**Brief of evidence of Henry John Hare relating to the  
CTV Building (249 Madras Street)**

**STRUCTURAL REPORT**

**OFFICE BUILDING  
249 MADRAS STREET**

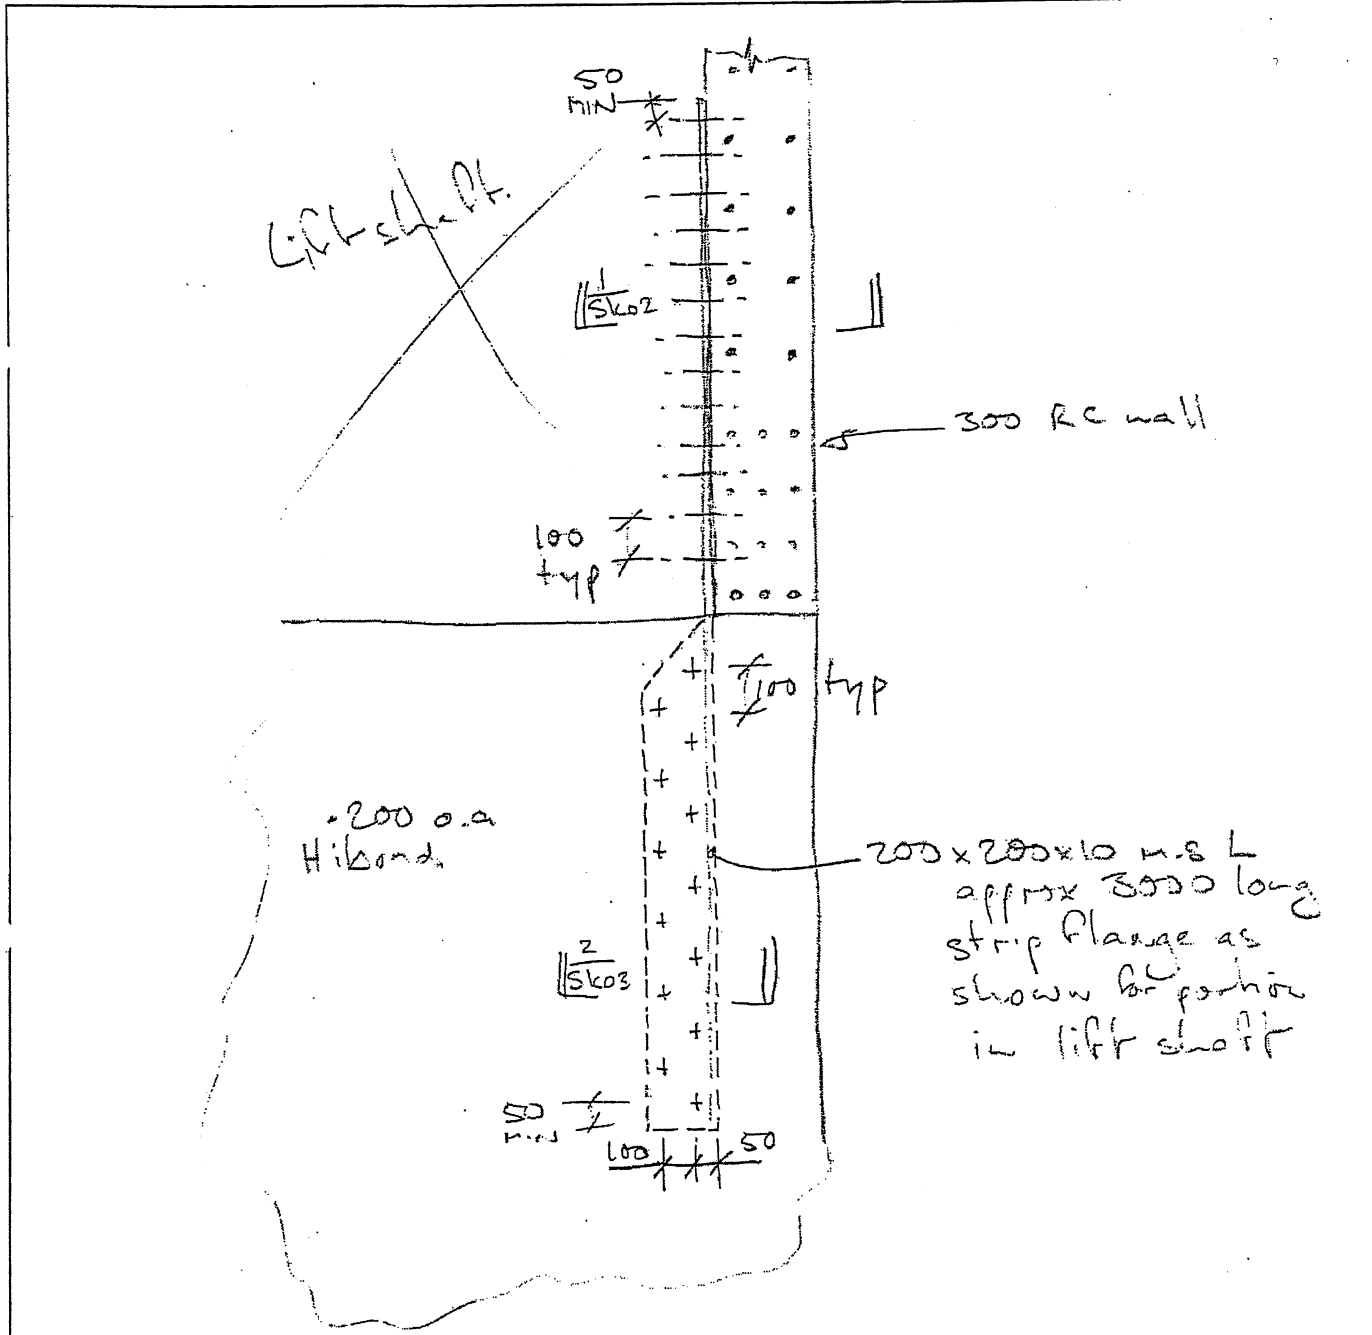
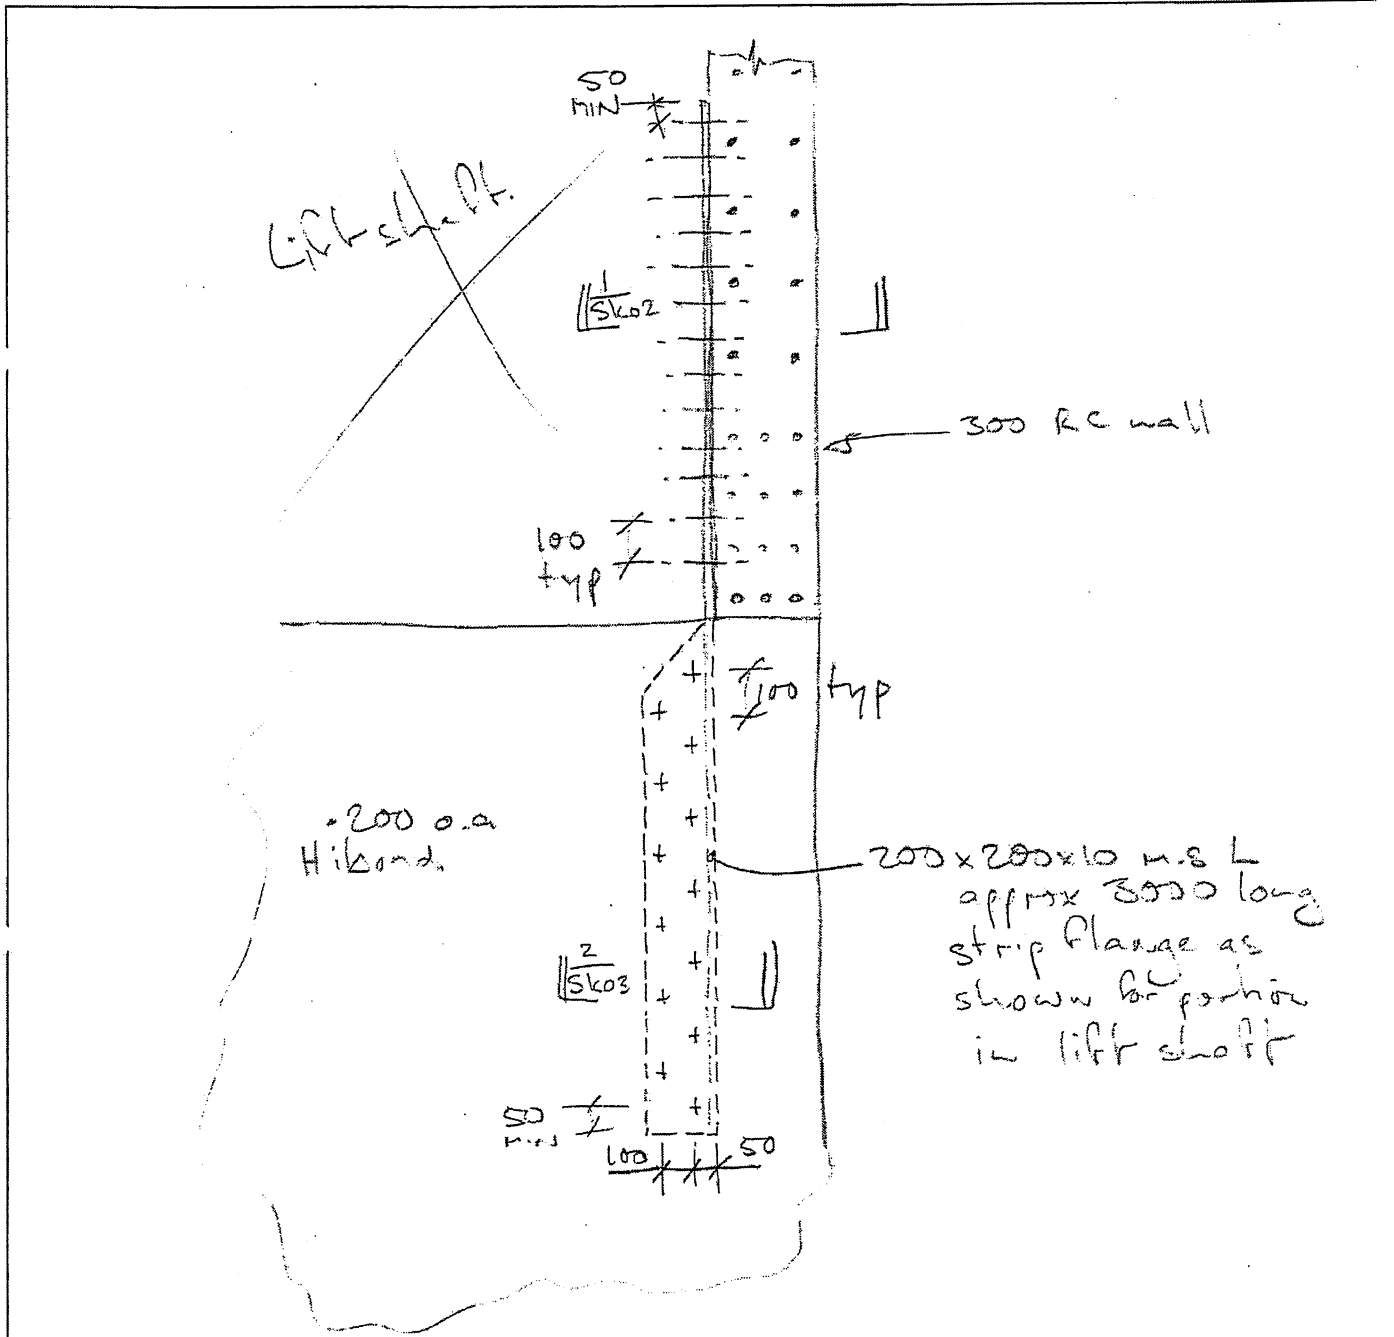
- 40 I developed a possible remedial detail on 31 January 1990, to give a preliminary estimate of the cost of establishing a connection between the north core and the floors. [BUI.MAD249.0005.19-20].

- 41 My draft remedial detail involved:
- 41.1 The insertion of steel diaphragm strengthening members (drag bars) on Levels 1 to 5 of the CTV Building (by Levels 1 to 5, I was referring to all levels above the ground floor car park. In my calculations and in the HCG Draft Report, HCG refers to the floors in the CTV Building as the Ground floor and then levels 1 to 5 above the Ground floor. In contrast, ARC refers to the Ground floor as Level 1 and the floors above the Ground floor as Levels 2 to 6).

- 41.2 A piece of steel angle being cut to shape and fixed to the lift walls and the underside of the slab, with drilled and epoxied anchors. There were to be two such ties per floor, to the wall on grid D and the east wall part way between grids D and E. In my view, such a detail was required to improve the connection between the floor slabs and the walls of the North core.

- 41.3 Consideration of the specifics of fixing to a thin wall and a thin slab. I recommended the use of 12mm diameter mild steel rods for connection to the wall, being the largest diameter reinforcement that could be practically developed into the 300mm wall. Likewise, I limited the size of the connections into the underside of the slab, and recommended coring and grouting from above, due to concerns I had with overhead epoxying and grouting.

- Require similar detail but handed at other side of lift shaft.
- Detail typical to levels 1 to 5.
- Reinstate all finishes when work completed eg ceilings, carpet.
